TRANS/SC.3/WP.3/2002/21  
18 April 2002

**ECONOMIC COMMISSION FOR EUROPE  
INLAND TRANSPORT COMMITTEE**

**AMENDMENT OF THE EUROPEAN CODE FOR  
INLAND WATERWAYS (CEVNI)**

66	
Article 3.32 Prohibited to smoke, or use an unprotected light or flame.

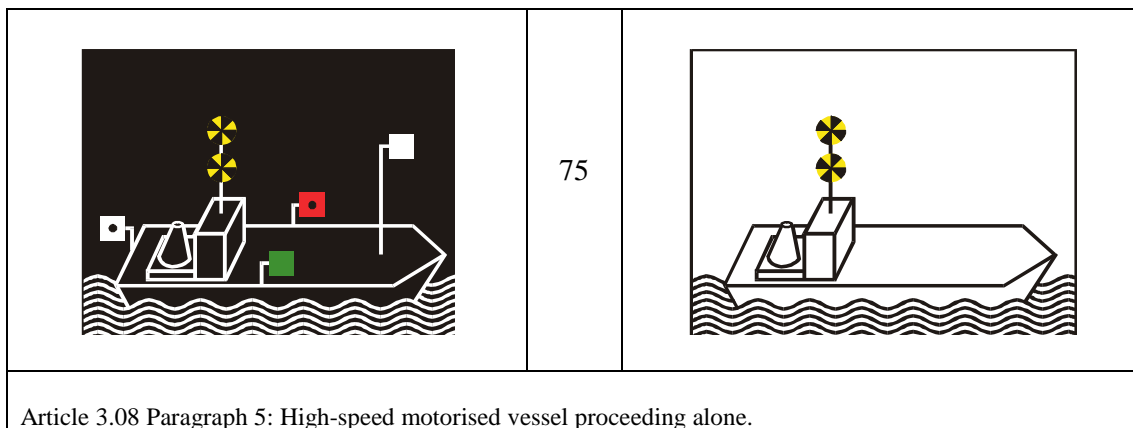
7. Modify the sketch 66 as follows:

**circular white boards bordered with red, with a red diagonal and a picture of a cigarette emitting smoke.**

**The boards shall be placed on the vessel or on the gangway, as circumstances require. By derogation from article 3.03, they shall be about 60 cm in diameter.**
